ADDENDUM

Re Addendum No. 1 to the Construction Documents for:

Central Maine Community College
ECE Area Renovation
Auburn, Maine
Project No. 16611

NEW PARTIAL ROOF PLAN
B1/A70.1

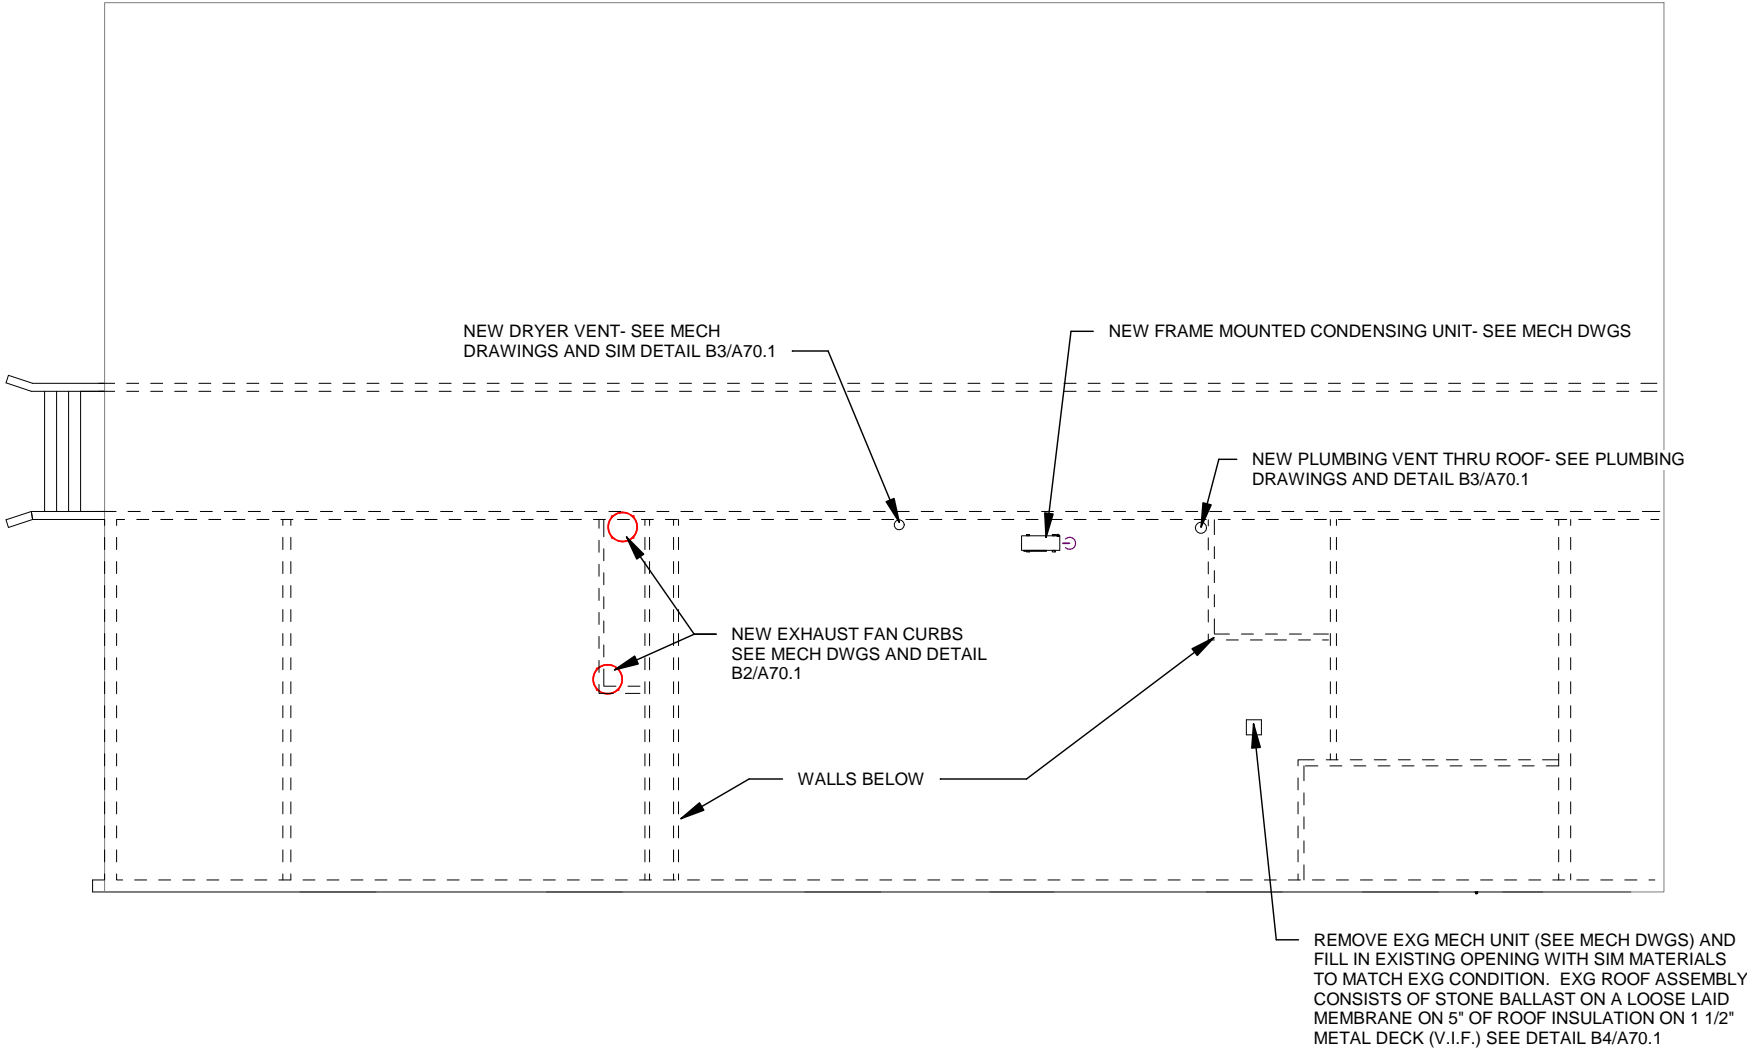
- b. Add the following to the drawing sheet A70.1: SKA02, SKA03, SKA04, SKA05.
5. DRAWING A81.1: INTERIOR ELEVATIONS
 - a. Elevation A1: graphically change the door height of door #219 to show a 8’-0” tall door.
